CORRIDOR REVIEW COMMITTEE

**CORRIDOR REVIEW COMMITTEE
STAFF REPORT AND RECOMMENDATION**
Prepared for January 8, 2026 Meeting

Application HP2026-0025

Project description: For Design Review to construct a second story addition on an existing one-story commercial building within the King Street Entry Corridor.

Rear (North) side of property.
Proposed exterior metal stair
location.

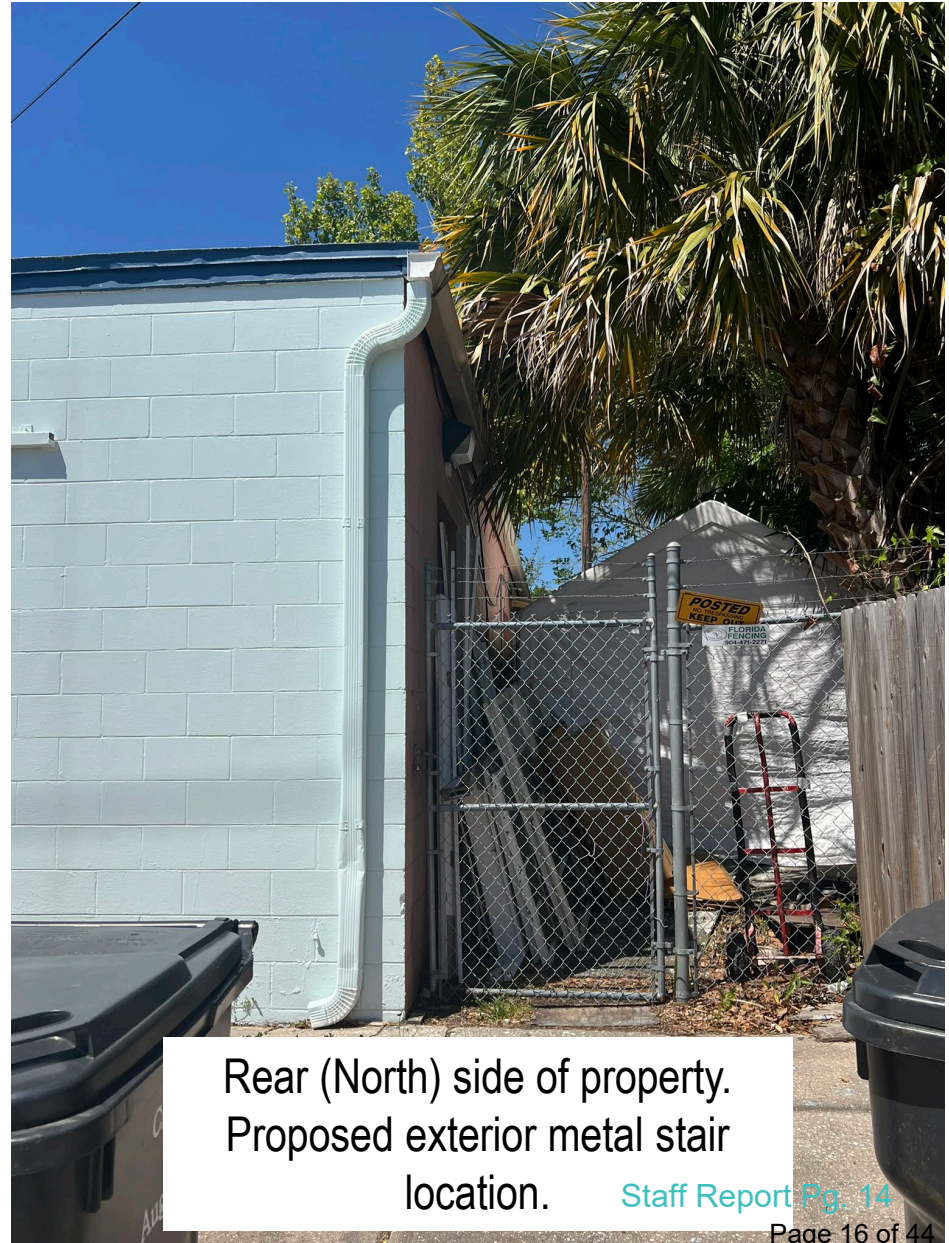
6. A painted metal stair and railing are proposed at the rear of the building. Prefabricated metal materials are generally considered inappropriate within the Entry Corridor unless approved by the CRC as a design consistent with intent of the Standards. The CRC should determine whether this feature is consistent with the architectural style of the building and the Standards as proposed. Changes in design and/or material may be recommended by the CRC.

② SOUTH (FRONT) ELEVATION
 1/4" = 1'-0"

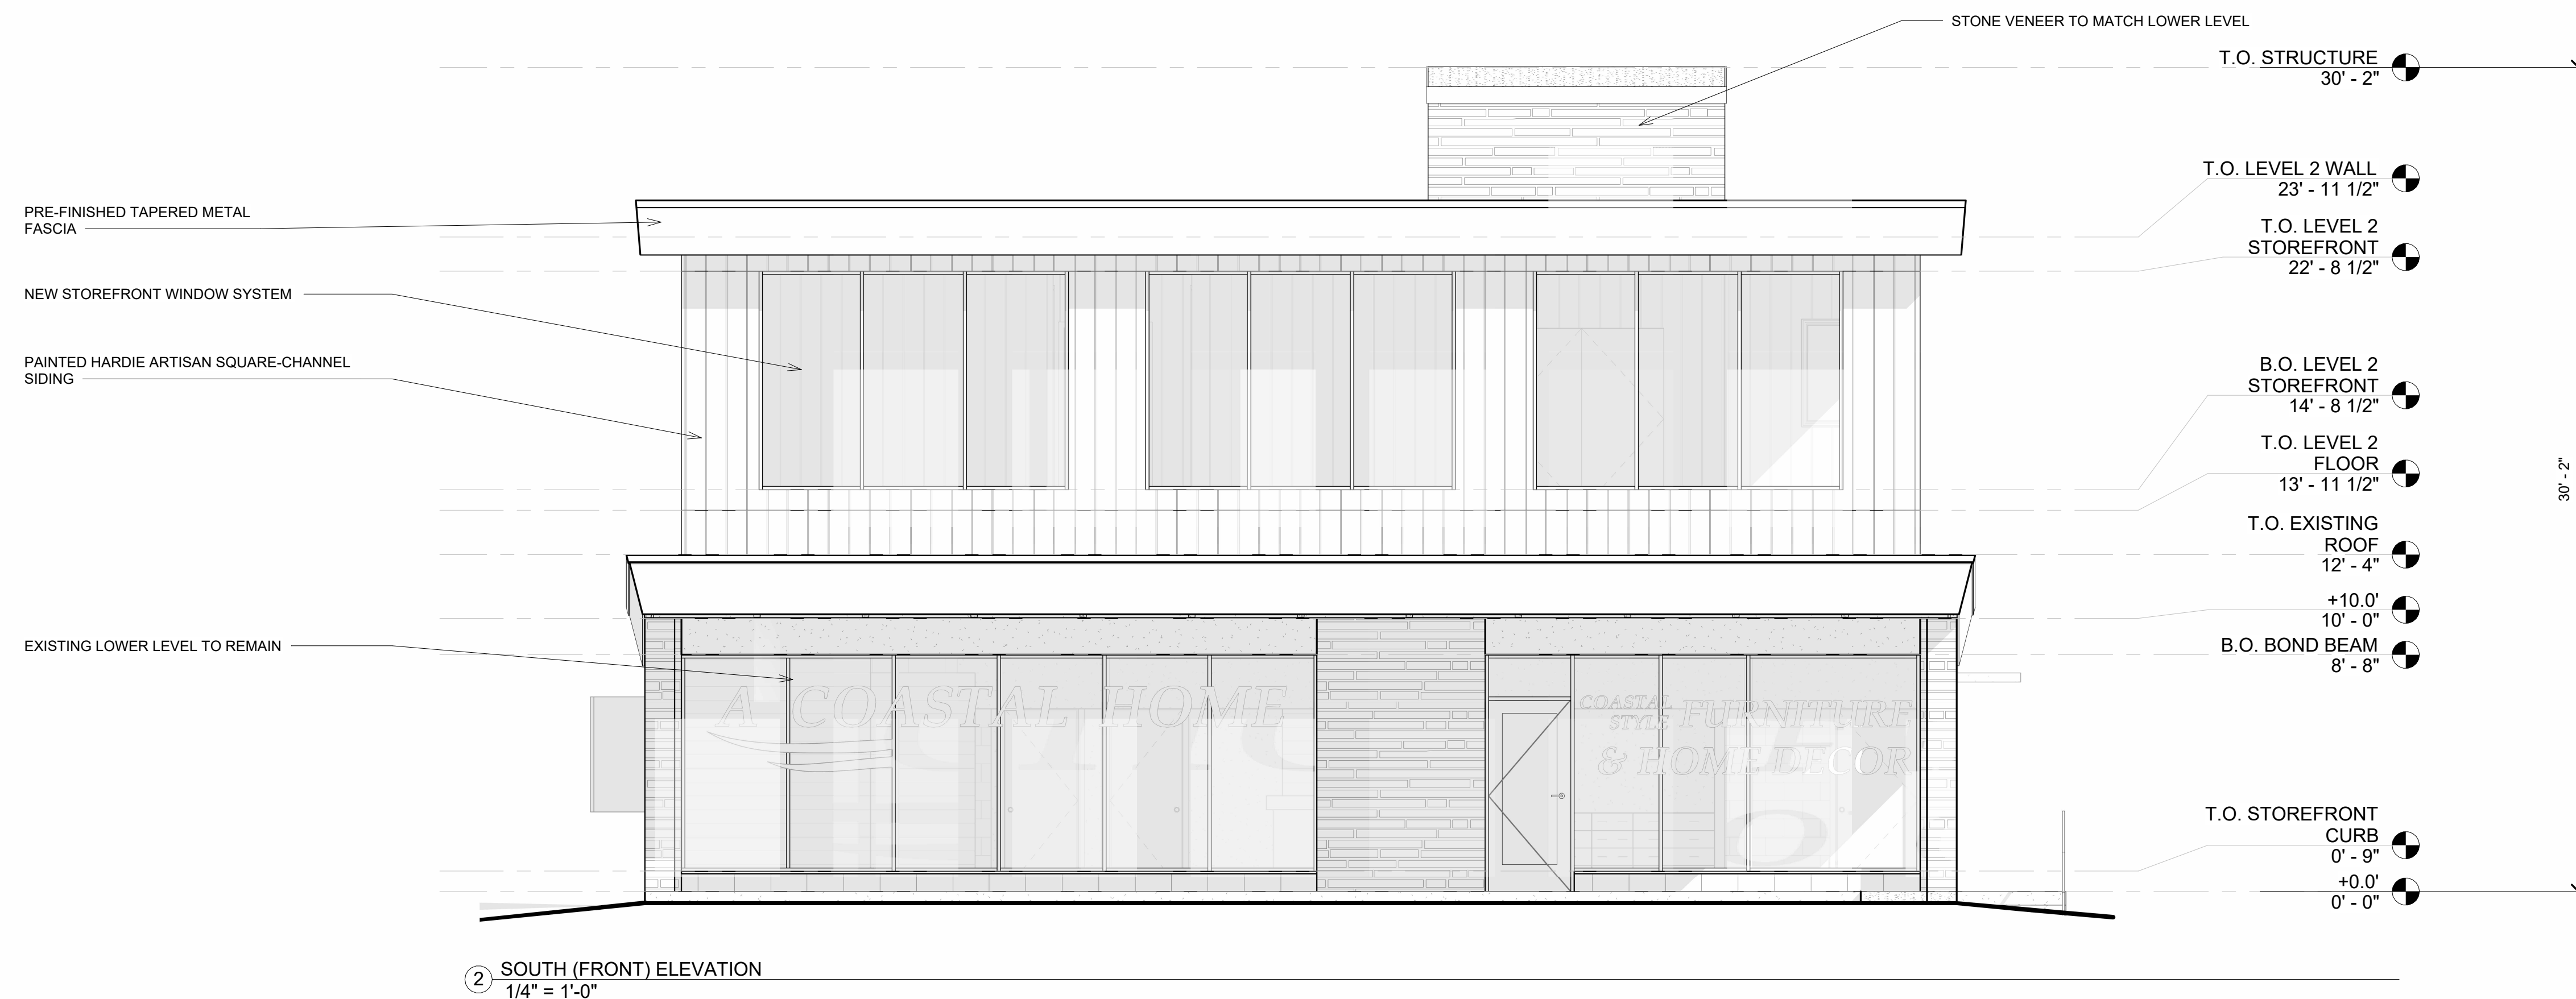
7. A Modification to the Standards for second-story window glazing has been requested by the applicant. Section 4.4.5 of the Standards allows for a maximum of 40% of glazing for second story windows calculated by adding the total square footage of windows and dividing that by the area of building frontage (width x 8') for each floor. The maximum allowed glazing for the proposed second story addition is 153.6sf. The CRC can approve a modification of up-to 30% of the allowed maximum, bringing the total approvable maximum glazing to 199.68sf. The proposed glazing for the new addition is above what can be approved by the CRC at 271.92sf. The applicant may consider the following options for approval of the windows:

- a. Window sizes could be reduced to meet the CRC-approvable square footage. A reduction in window height of at least ~2.13' would allow for CRC approval, and the more defined horizontal orientation of the shortened windows would be consistent with the Mid-Century Modern design. Glazing Calculations have been attached to this staff report for reference.

- b. The applicant could seek approval of a Variance to the Design Standards from the Planning and Zoning Board (PZB) for the proposed glazing amount.

① EAST (SIDE) ELEVATION
 1/4" = 1'-0"

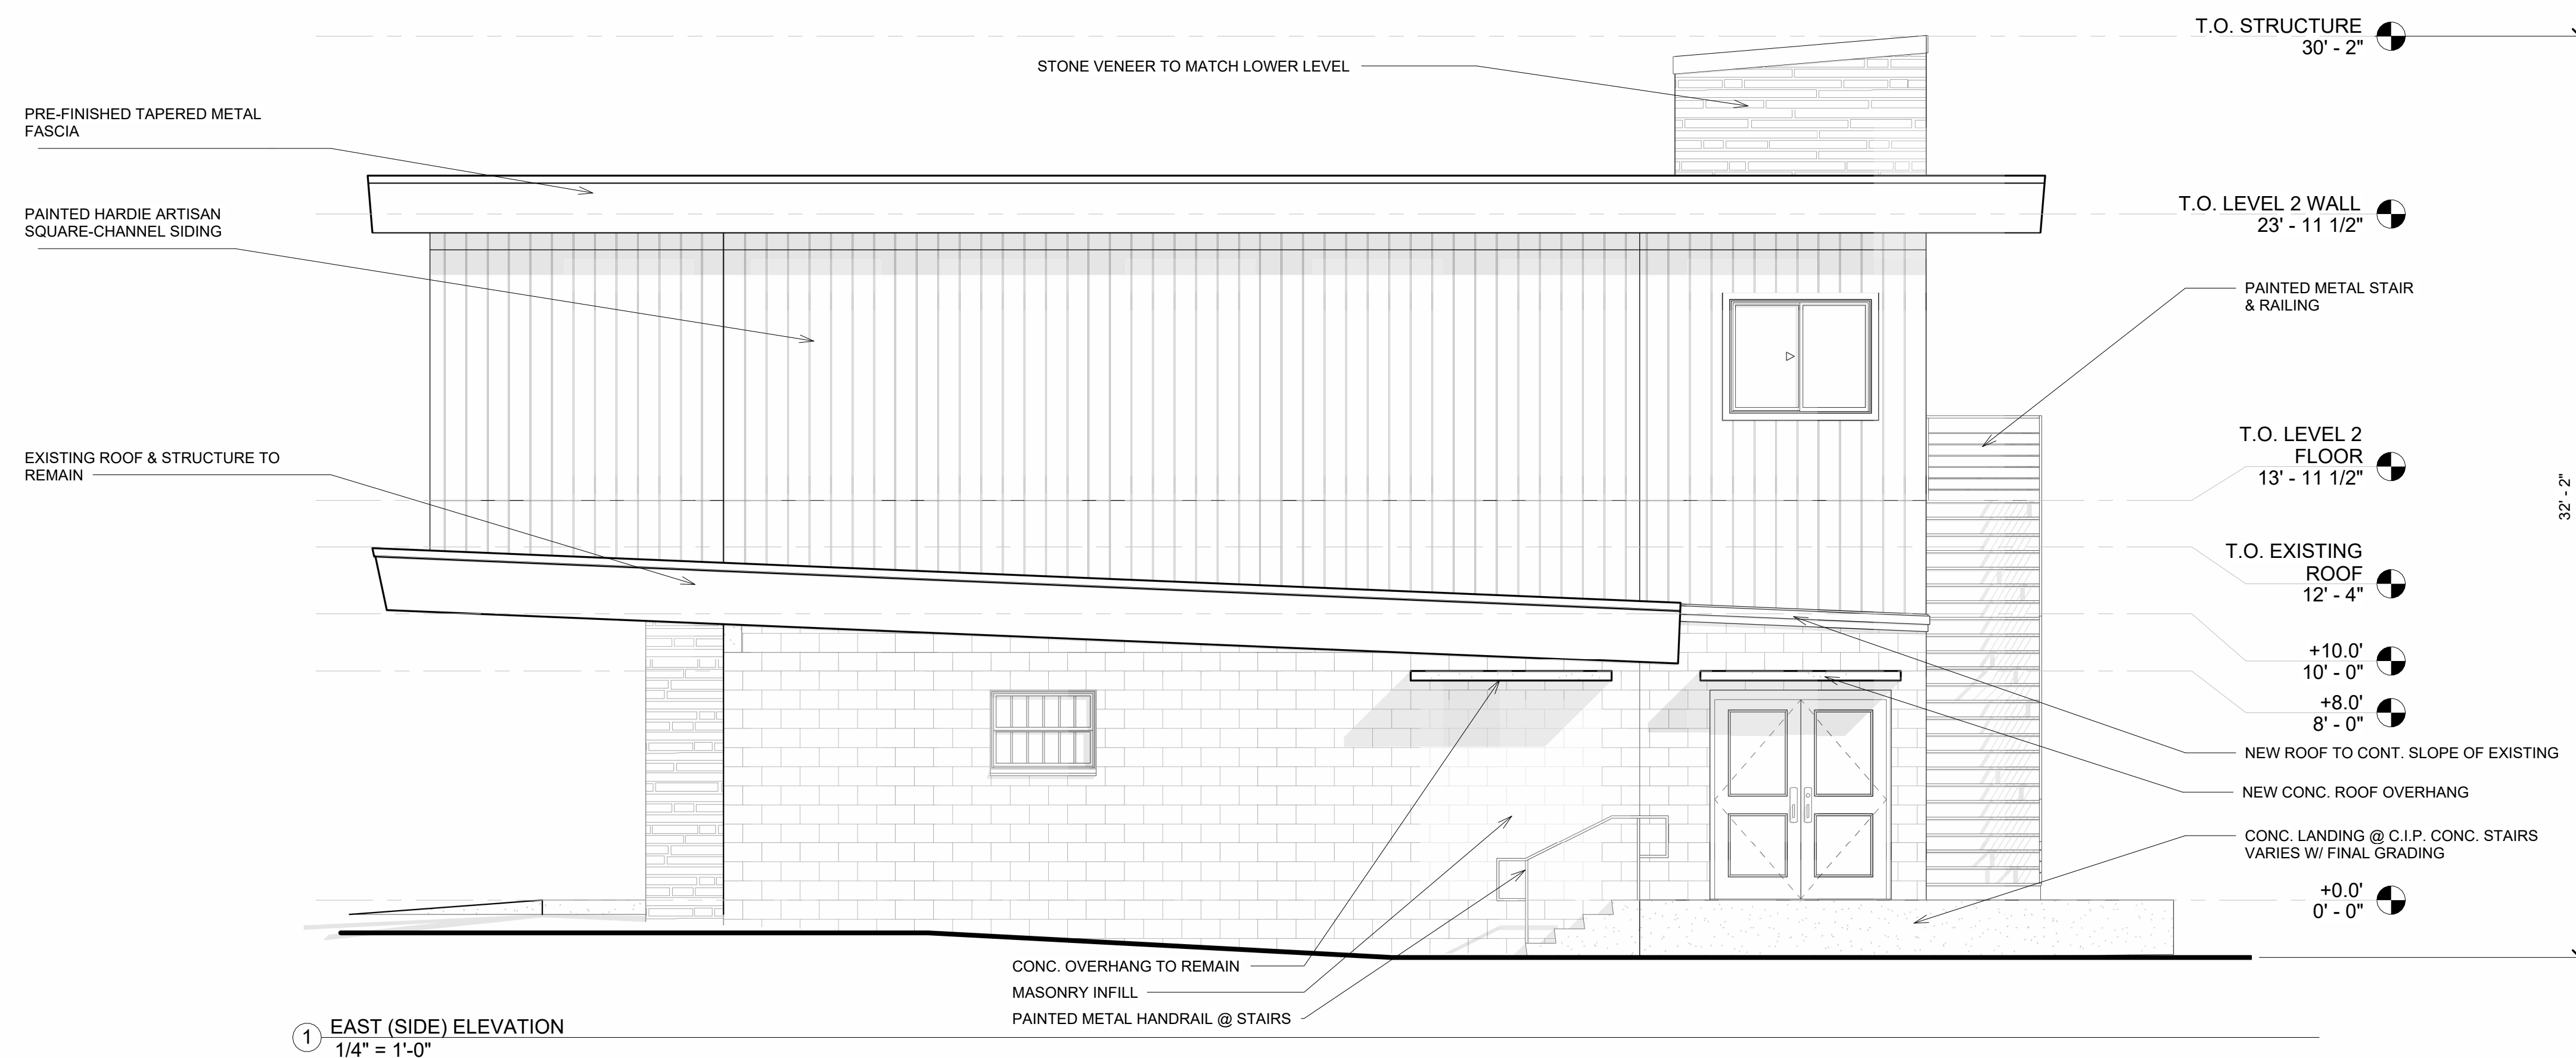
8. Alterations to the existing structure include relocation of an existing double door on the east elevation, facing N. Leonardi Street, with a new concrete landing and access stairs with painted metal handrail. Two new windows are proposed on the west elevation. One will connect to a window on the north elevation with a wrap-around "catio" feature.
